**SPECIALTY GRANULES LLC
PROPOSED NORTHERN TRACT QUARRY
RESPONSE TO PUBLIC COMMENTS RECEIVED AT JULY 23,
2018 PUBLIC MEETING AND RELATED PERIOD FOR
SUBMISSION OF WRITTEN COMMENTS**

**Large Noncoal Surface Mining Permit Application No. 01180301
NPDES Permit Application No. PA0279617**

Submitted: November 12, 2018

Figure 4.1 – Burden and Spacing

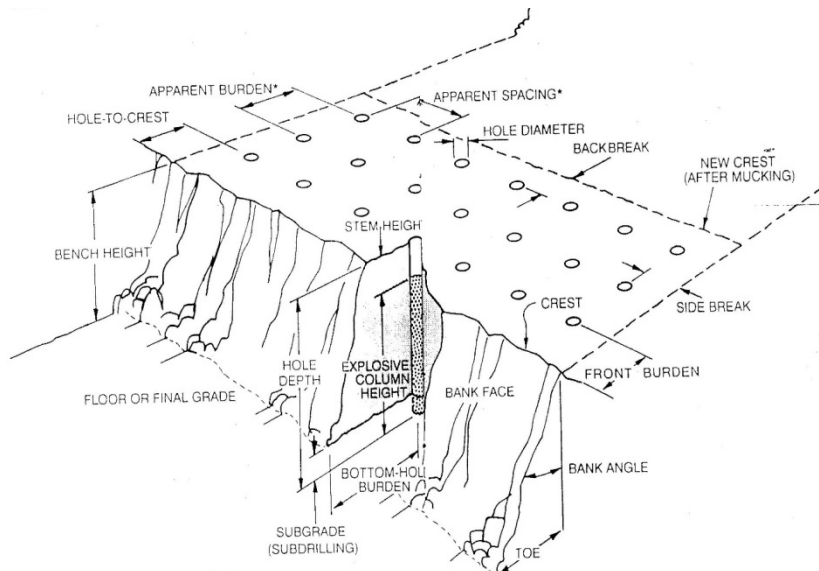
SGI further asserts that it will "use best management practices and blasting plans to minimize noise levels (over pressure) associated with blasting," see Module 17.3. Yet, again, SGI does not identify what best management practices will be utilized or what decibel reduction can be expected as a result. (FOTC/Fair Shake)

- SGI's practices have reduced the total blast event size in terms of the number of rows and/or holes per row.
- SGI's plan inverts the burden and spacing on the front row to provide more burden on the free face (see **Figure 4.1**). "Burden" is the distance from borehole to the free face and/or direction of movement. The "spacing" is the distance between holes in a row. The typical burden is 11 feet and spacing is 13 feet, but with "inversion" the front row utilizes 13 feet of burden and 11 feet of spacing. This reduces air overpressure from the opening row. SGI uses a laser instrument to precisely locate the drill holes in order to establish the design burden and spacing.

Figure 4.3 – Blasting Monitoring Stations

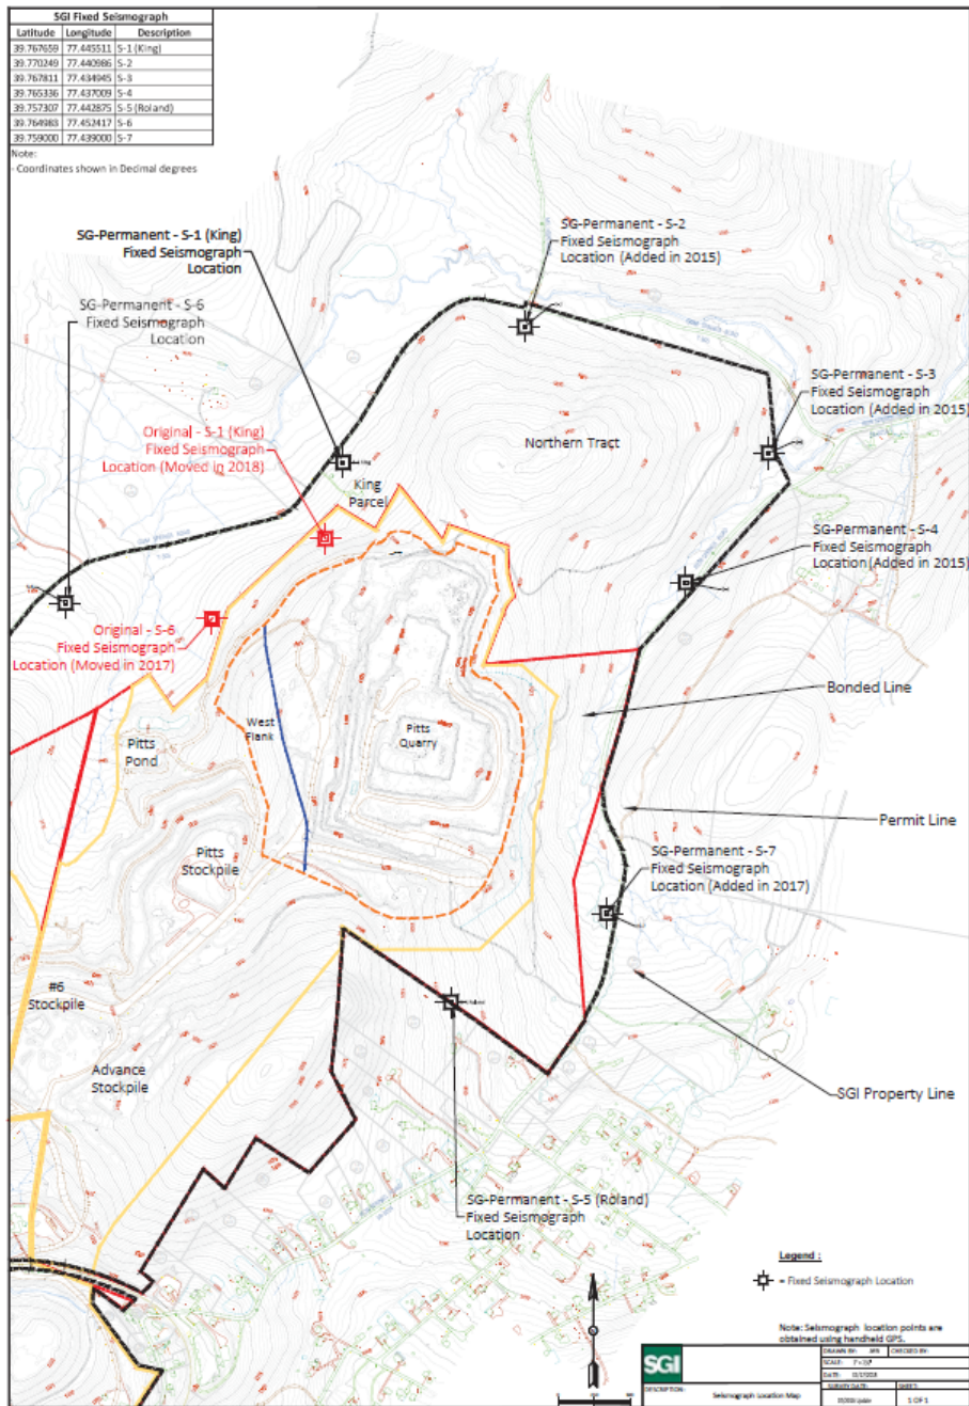
The question I have now is how far have they gone to this particular point, because the blasting which directly effects my property directly across from me is quite unnerving, and I'd like to know if the further down they go, is the blasting more significant, do you feel it more? (D. Paolini)

SGI engages a third party monitoring firm to maintain a robust network for monitoring blasts. That network currently consists of seven (7) fixed monitoring stations, each equipped with a seismograph, located on property owned by SGI (e.g., closer to the blasting than off-site residences and other buildings). These fixed stations, whose locations are shown in **Figure 4.3**, are labeled S-1 through S-7. As indicated in Figure 3, the location of these monitoring points has been adjusted in some cases over time as operations have changed and the network has expanded.
